# UNITED STATES PATENT AND TRADEMARK OFFICE

| APPLICATION NO. | FILING DATE | FIRST NAMED INVENTOR | ATTORNEY DOCKET NO. | CONFIRMATION NO. |
|-----------------|-------------|----------------------|---------------------|------------------|
| 10/635,249      | 08/06/2003  | Donald C. Roe        | 8556C               | 9458             |

| <b>Office Action Summary</b> | <b>Application No.</b> |  | <b>Applicant(s)</b> |  |

**FIG. 3**

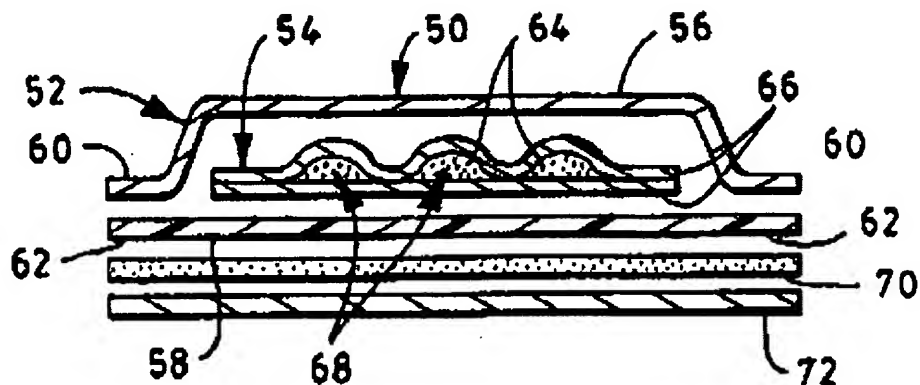
Regarding claim 1, Glaug *et al.* teach a wearable article (20) worn about the lower torso of a wearer, the wearable article comprising a temperature change element (22, 24, 56) including a permeable layer (56) an impermeable layer (58) disposed in a face-to-face arrangement with the permeable layer (56), and a temperature change substance (54, 64) interposed between the permeable layer (56) and the impermeable layer (58), wherein urine deposited onto the temperature change element (22, 24, 56) can penetrate through the upper permeable layer (56) in a z direction to the lower impermeable layer (58) and wherein the impermeable layer (58) prevents urine from passing completely through the temperature change element (22, 24, 56) in the z direction and supports the movement of urine in an x-y plane to wet the temperature change substance (54, 64)(col. 7, lines 16-59; col. 8, lines 21-36)(see figure 3, below).

Regarding claim 4, Glaug *et al.* teach that the temperature change element (22, 50) comprises a multiplicity of compartments (68) and the temperature change substance (64) is disposed in each of the compartments (68)(figure 3).

Regarding claim 5, Glaug *et al.* teach that the temperature change element (22, 50) comprises a multiplicity of fluid channels disposed parallel and between the compartments (68)(figure 3).

Regarding claim 6, Glaug *et al.* teach that the upper permeable layer (56) faces the body of a wearer (figure 3).

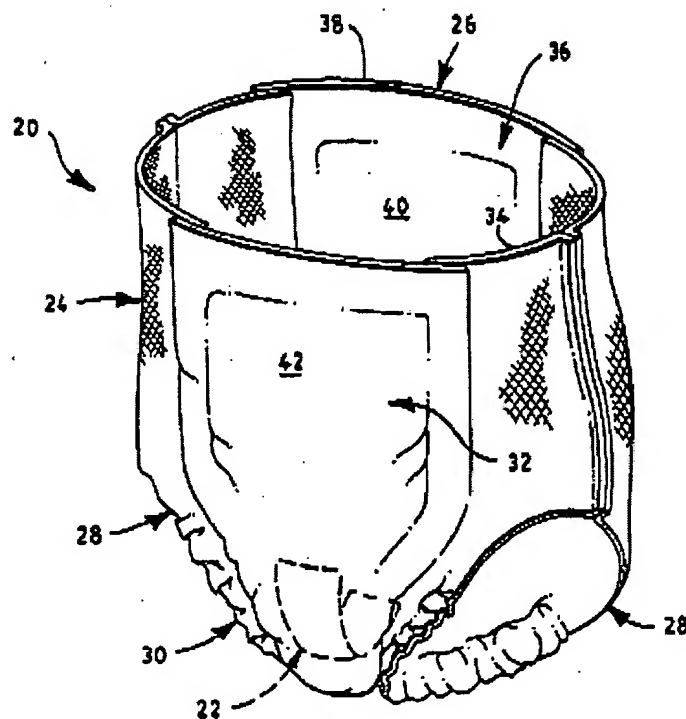
Glaug *et al.* imply that side elastic materials may be used with that article (col. 14, lines 16-29)(see element (28) in figure 1, below).

Glaug *et al.* do not expressly disclose that such elastics are elastically foreshortened.

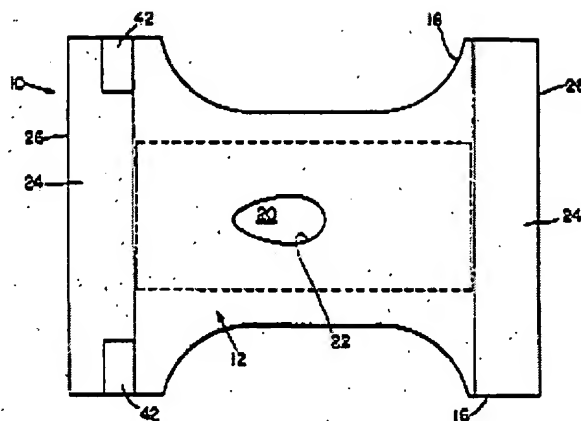
Freeland teaches an absorbent article (10) with elastically contracted side edges which allow the article to better conform to the anatomy of a wearer (see figure 1, *infra*).

At the time of the invention, it would have been obvious to one of ordinary skill in the art to add the elastically contracted side elements of Freeland to the article of Glaug *et al.* in order to provide form improved fit on a wearer.
